SMCCCD - Skyline College

Appendix F: Curb Ramps

Access Compliance Survey Report

Perpendicular**1 Ramp Slope**• *As-Built Description:*

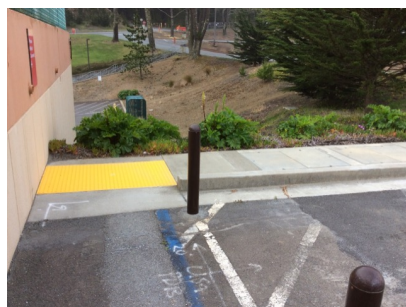
Running slope of existing perpendicular curb ramp is less than 5% or greater than 8.3%.

• *As-is* **11.6%**• *Proposed Solution:*

Demolish existing and provide new, perpendicular curb ramp, including detectable warning surfaces, and top and bottom landings as required.
